Entergy Operations, Inc.
1340 Echelon Parkway
Jackson, MS 39213

G3NO-2008-00011

DOCKET: No. 52-024

SUBJECT: Responses to NRC Requests for Additional Information, Letter No. 09
(GG3 COLA)

Figure 1.1-201. Unit 3 Site Plot Plan

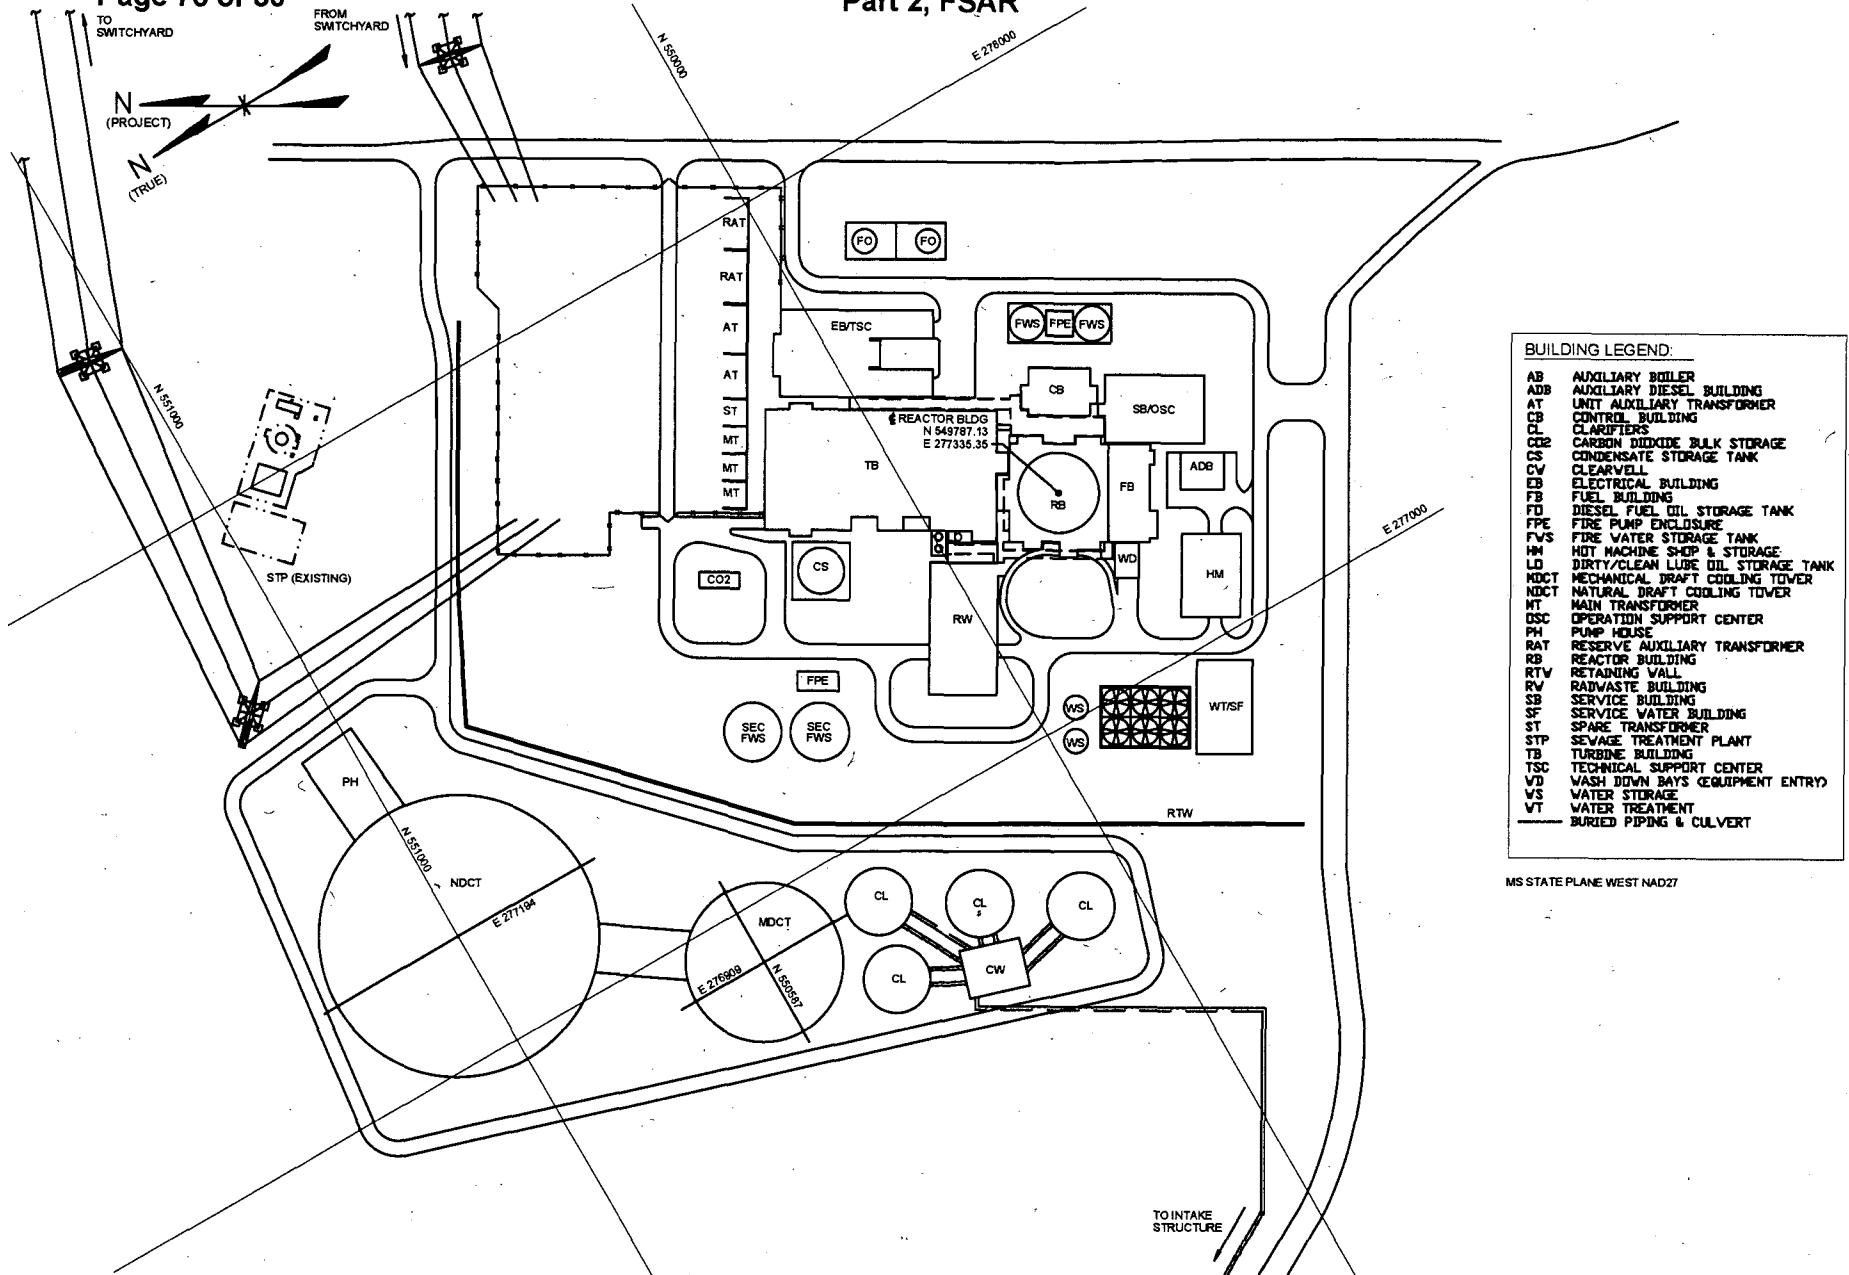
Changes in ESBWR standard plant design in DCD Revision 5 deleted the single plant stack for routine gaseous effluent releases and replaced it with ventilation stacks for the Reactor/Fuel Building, Turbine Building, and Radwaste Building. Revision 5 to the DCD also changed the gaseous effluent release source term (DCD Table 12.2-16 and Table 12.2-17) resulting in the ESP gaseous release source term not being bounding for all isotopes (ESP source in ESP-002 Appendix D, "Values of Plant Parameters Considered in the Environmental Review of the Application," Tables D1 and D7; and in SSAR, Tables 1.3-1 and 1.3-2). DCD Revision 5, Table 2.0-1 also included revised site parameters for the long-term atmospheric dispersion coefficients. The COLA will be revised to provide new site characteristic long-term dispersion coefficients considering the revised release locations in the DCD. Estimates of dose from routine gaseous releases will be revised using the DCD gaseous normal release source term (DCD Table 12.2-16 and Table 12.2-17) and the revised site-specific long-term dispersion coefficients.

- Various FSAR figures (Figures 1.1-201, 2.1-202, 2.4.1-201 Sheets 1 and 2, and 2.4.2-204), to reflect removal of the main plant (off-gas) stack from the site plan
